CCK-2568-22

ADDENDUM # 4

CONSTRUCT/ IMPROVE GREEK HOUSING (DELTA GAMMA) Bid Package #2 – All Work Categories

UNIVERSITY OF KENTUCKY
 2555.0 Construct/Improve Greek Housing
 (Delta Gamma House)

FIRST FLOOR DEMO PLAN

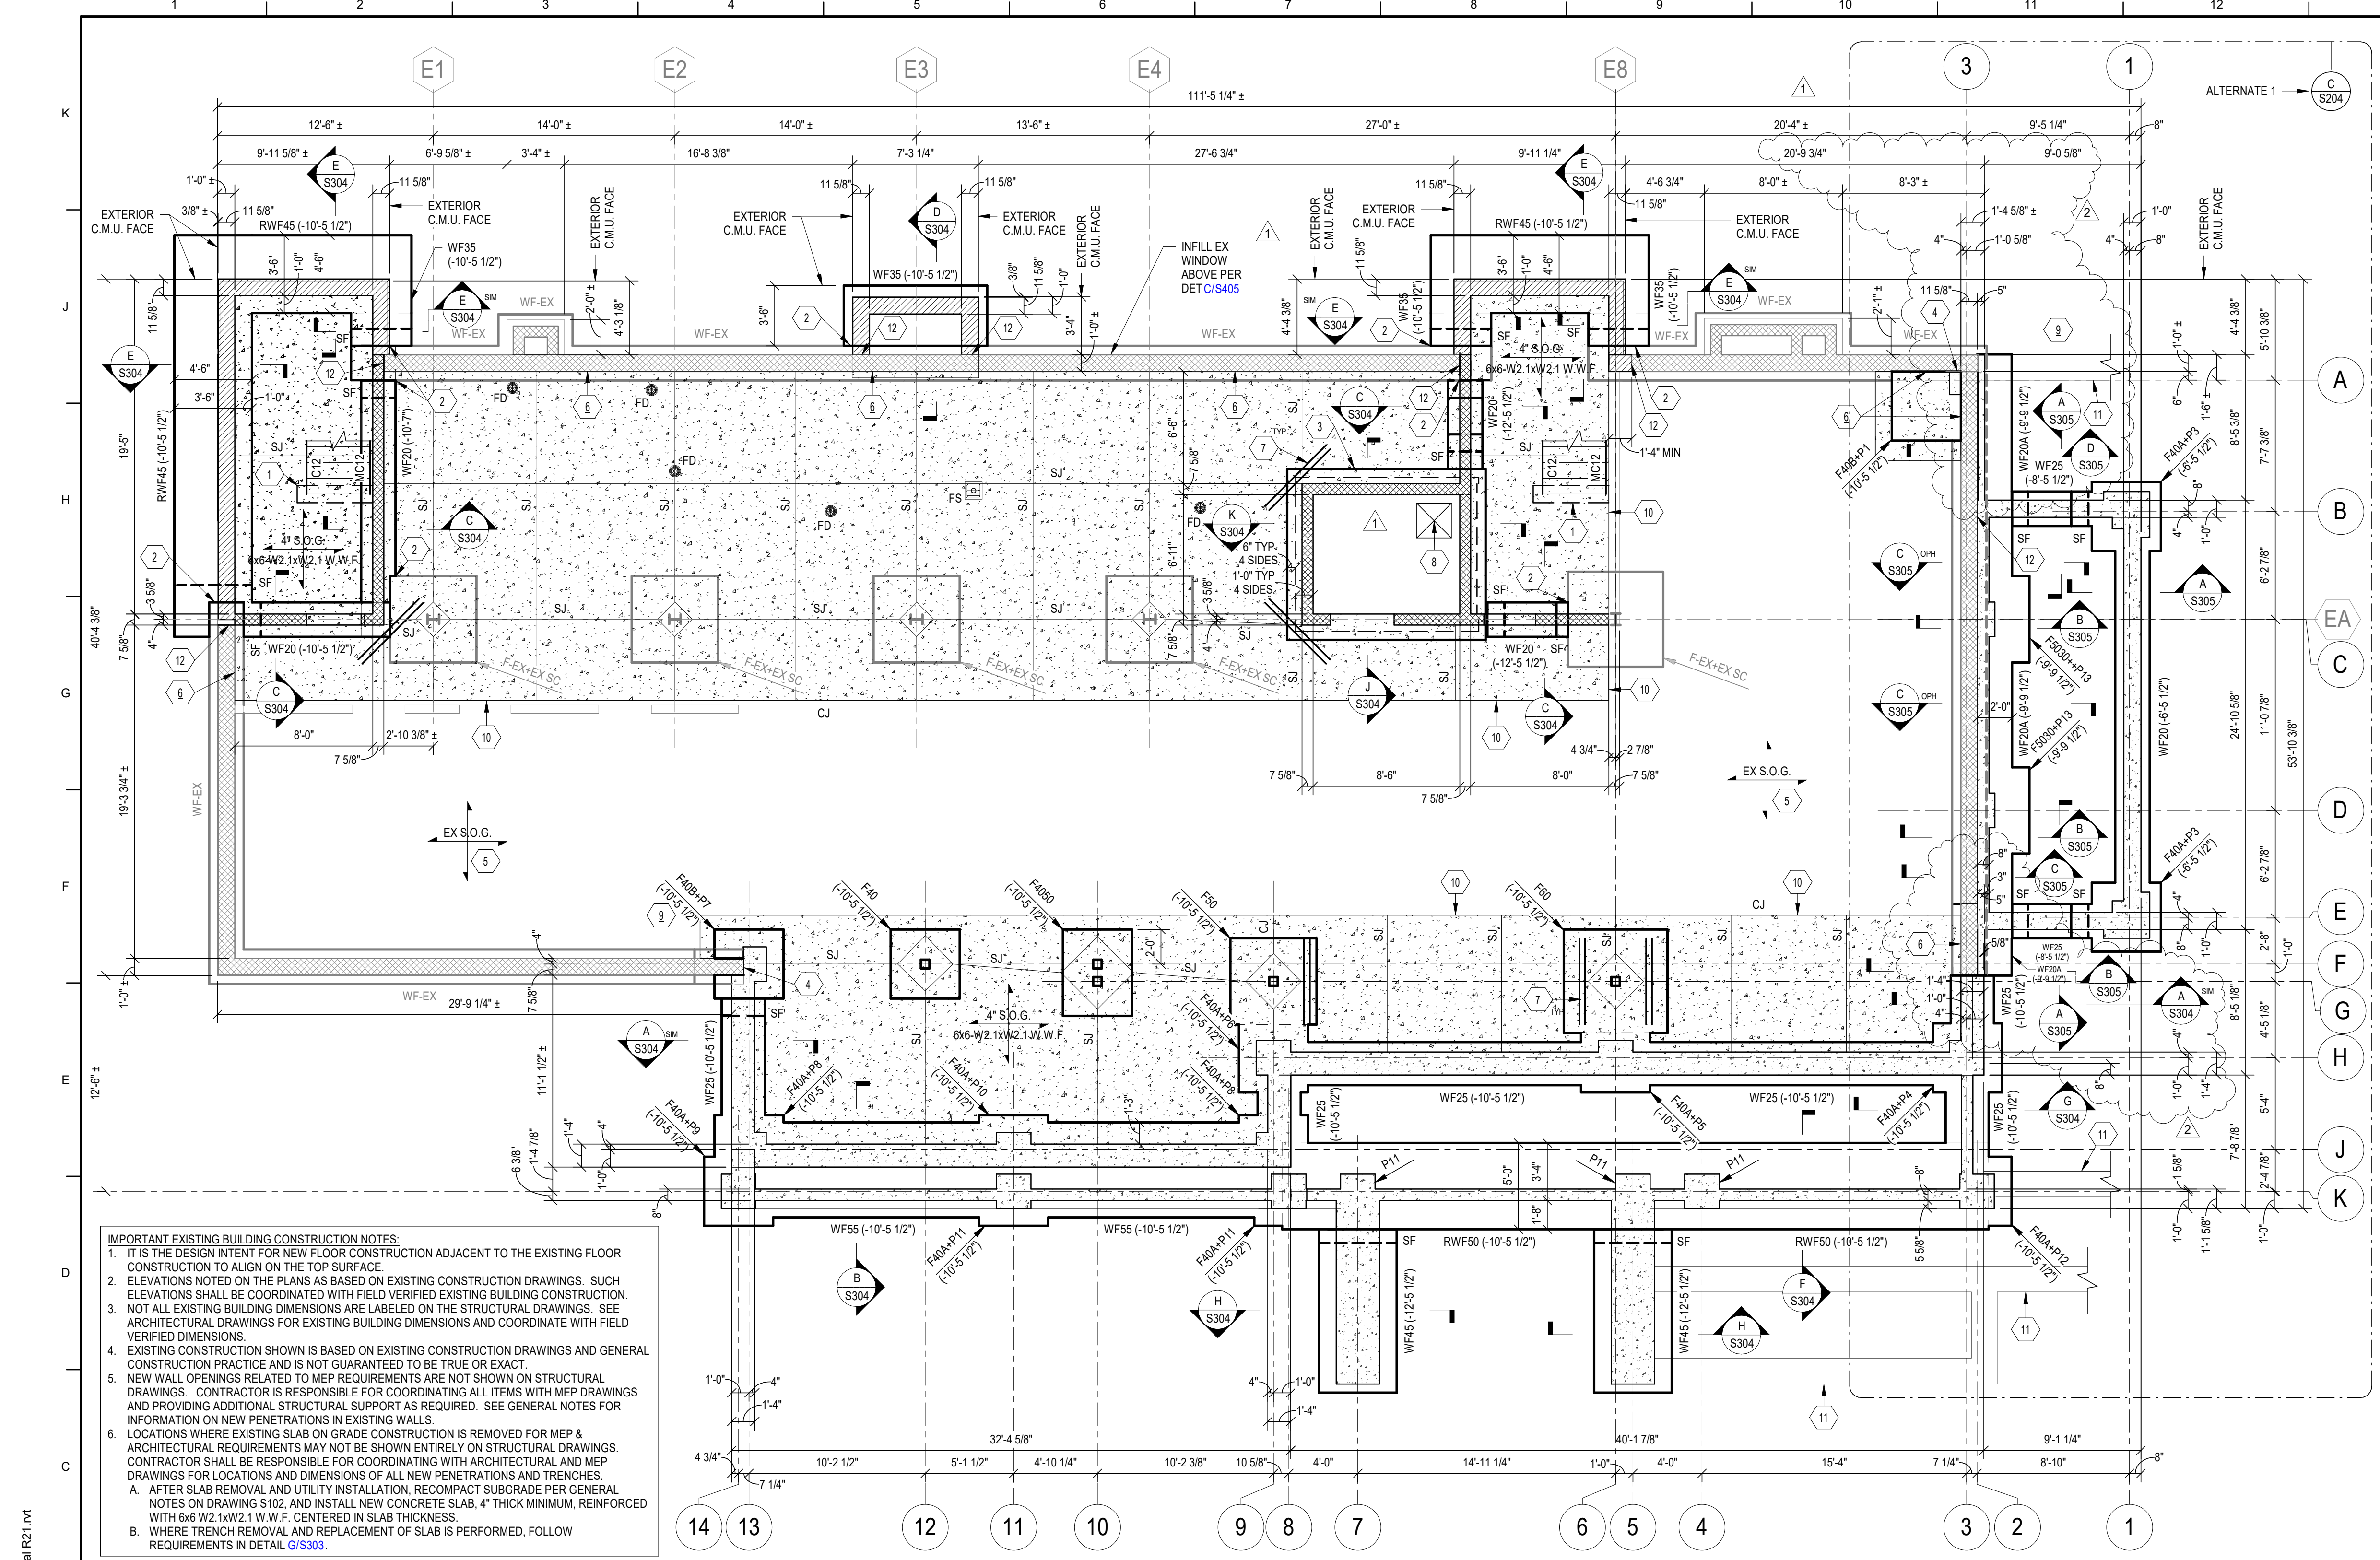
SD201	FIRST FLOOR DEMO PLAN	9/7/21
	<ul style="list-style-type: none"> • Updated plan for shoring locations. 	
S200	FOUNDATION/BASEMENT PLAN	9/7/21
	<ul style="list-style-type: none"> • Revised plan for new brick ledge on plan east side of existing building structure. 	
S201	FIRST FLOOR FRAMING PLAN	9/7/21
	<ul style="list-style-type: none"> • Revised plan for new brick ledge on plan east side of existing building structure. • Added note and tag notes for existing joist at new column installation along grid 3. • Edited stair embed labels at plan west wall. • Modified stairwell framing. • Changed Tag Note 31 to "NEW JOIST BEARING PER DET L/S402 OR DET J/S404." 	
S202	Second Floor Framing Plan	9/7/21
	<ul style="list-style-type: none"> • Edited stair embed labels at plan west wall. • Modified stair well framing. • Changed Tag Note 31 to "NEW JOIST BEARING PER DET L/S402 OR DET J/S404." 	
S203	ROOF FRAMING PLAN	9/7/21
